Louis Schreiner Field
Kerrville, Texas 78028

SERVICE BULLETIN M20-283A

- SUBJECT:** EXHAUST DEFLECTION SHIELD, FIREWALL
- MODELS/ S/N AFFECTED:** MOONEY M20M, (MOONEY TLS – MOONEY BRAVO)
S/N 27-0001 THRU 27-0321 EXHAUST DEFLECTION SHIELD MODIFICATION.
SN 27-0001 THRU 27-TBA FOR V-BAND CLAMP REMOVAL & REPLACEMENT.

FIGURE SB M20-283-1

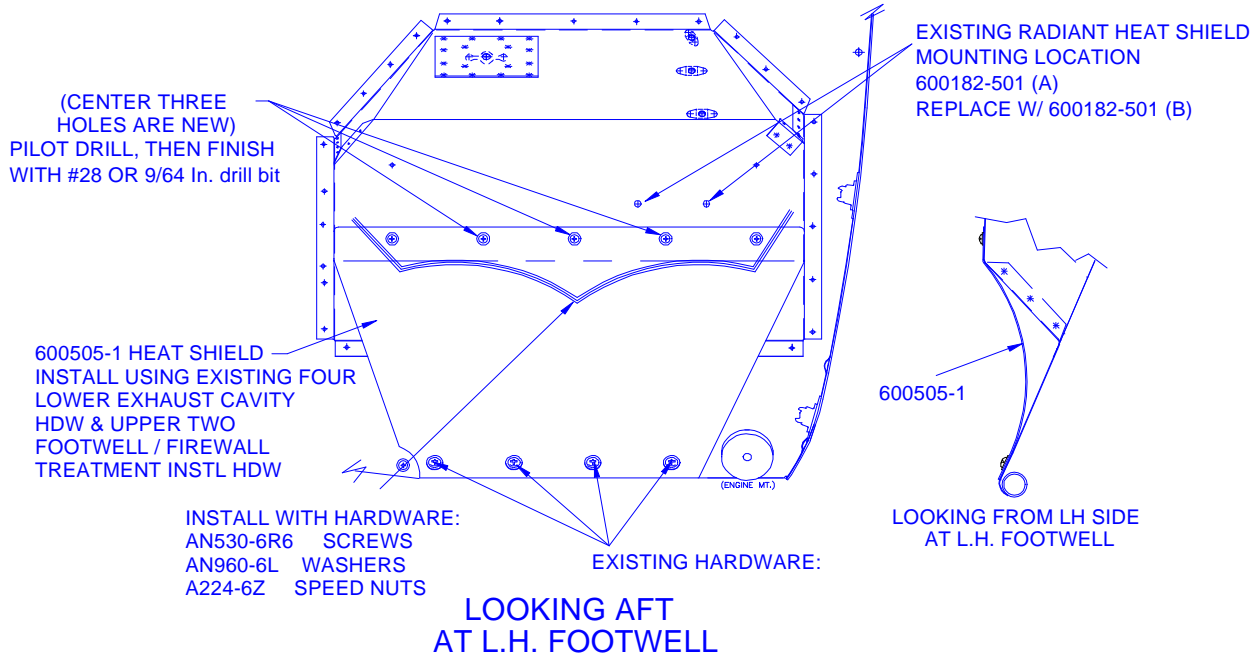
7. Place 600505-001 Heat Shield, Deflector over the location where it will be mounted (Reference Figure SB M20-283-1). Loosely, connect the Heat Shield, Deflector with the two outside, upper screws.

Deflector, between the two (2) already existing attaching holes in the lower portion of the footwell (Reference Figure SB M20-1).

FIGURE SB M20-283 - 3

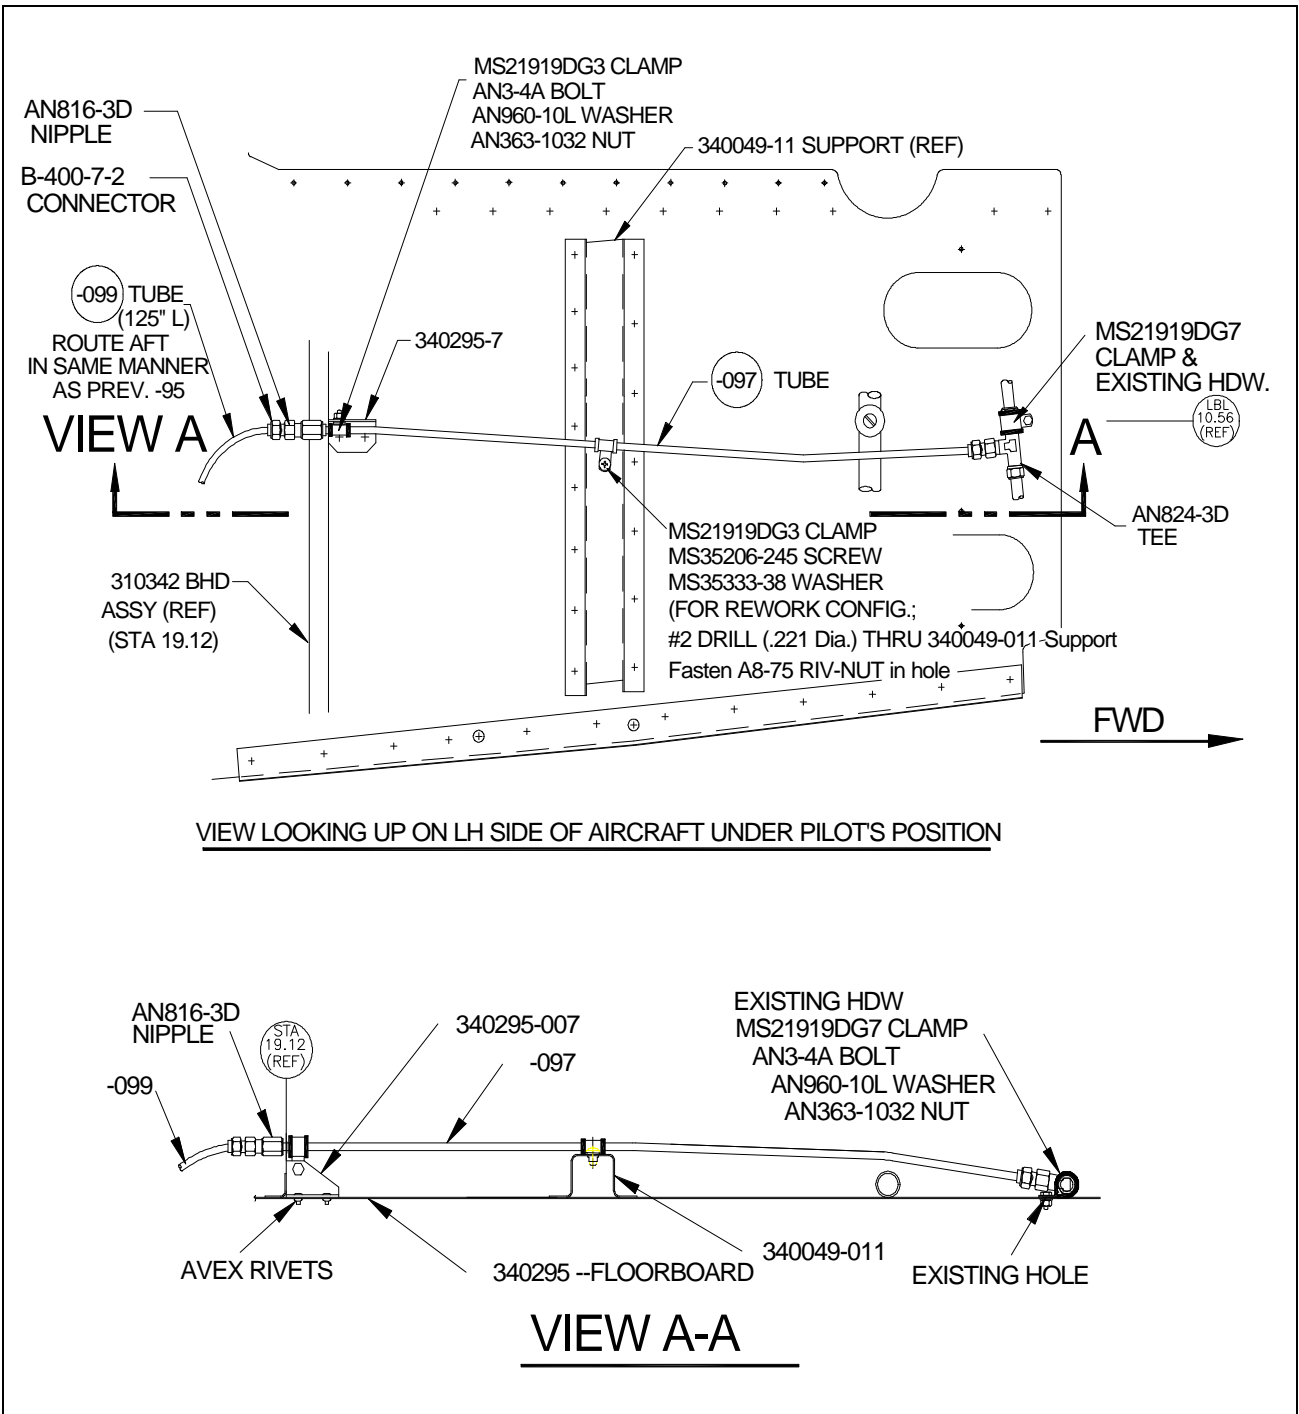
16. Gain access to area aft of Firewall, below cabin floorboard, where hydraulic fluid from reservoir is routed via a poly line up through the floorboard to Brake Master Cylinders in Cabin. [Refer to Figure SB M20-283-3]

17. To shut off the supply of brake fluid from the reservoir to the Master Cylinders, it is recommended that the poly line be cut and clamped shut, midway between Fuselage Station 19.12 bulkhead [See Fig. SB M20-283-3] and the Firewall. This will allow sufficient length for the poly line to be cut again to attach to the new bulkhead fittings for the new aluminum line and the shortened poly line.

23. Loosely attach new MS21919DG3 Clamp over –097 Tube. Use new hardware to attach clamp to Support, P/N 340295-007.
24. When –097 Tube Assy. is positioned and clear of bulkhead, fasten Support, P/N 340295-007 to floorboard forward of Fuselage Station 19.12 bulkhead with Avex pop rivets (2 places) [Reference Figure SB M20-283-3].

29. Refer to Figure SB M20-283-3 to locate floorboard Support, P/N 340049-011, which is located between the firewall and Fuselage Station 19.12. With 850109-097 aluminum line assembly and all fittings at both ends properly torqued, locate new MS21919DG3 Clamp and mounting hardware so that hole for securing clamp is positioned in relative center of the 340049-011 hat section support member.
